**FEDERAL AVIATION ADMINISTRATION  
AIRWORTHINESS DIRECTIVES  
SMALL AIRCRAFT, ROTORCRAFT, GLIDERS,  
BALLOONS, & AIRSHIPS**

**BIWEEKLY 2012-03**

## **AIRWORTHINESS DIRECTIVE**

Figure 1

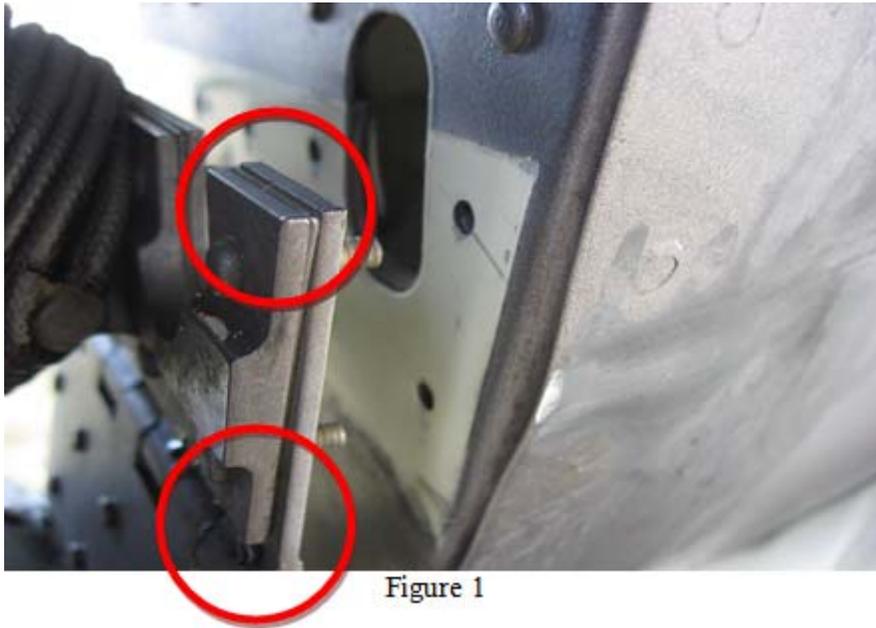
Mooney inspected several other aircraft and found that on one airplane the filler plate was incorrectly installed. The filler plate was not correctly installed between the aft side of the hinge and the bulkhead. Instead, the filler plate was located on the forward side of the hinge between the hinge and trim fitting. It was then noted the incident aircraft had the same issue, as shown in the upper circle of figure 1.

Because the hinge has a lip on the bottom, on the side toward the bulkhead (as shown in the bottom circle of figure 1), if the filler plate is not installed correctly, the hinge will not fit flush against the bulkhead, the Huck Bolt fasteners will not fit perpendicular to the bulkhead, and the collars will not swage properly. The condition also causes excessive tension pre-load on the Huck Bolts.

This AD requires inspecting the trim fitting, hinge, and filler plate of the tail pitch trim assembly for correct positioning and proper attachment, and inspecting the Huck Bolt fasteners for proper security. If incorrect positioning or improper/loose attachment is found, the owner/operator must contact Mooney for FAA-approved repair instructions. The AD also requires sending the inspection results to the FAA and Mooney.

Before further flight after receipt of this emergency AD, inspect the trim fitting, hinge, and filler plate of the tail pitch trim assembly for correct positioning and proper attachment; and also inspect that the Huck Bolt fasteners are properly secured following Mooney Aviation Company, Inc. Service Bulletin No. M20-313, dated February 7, 2012.
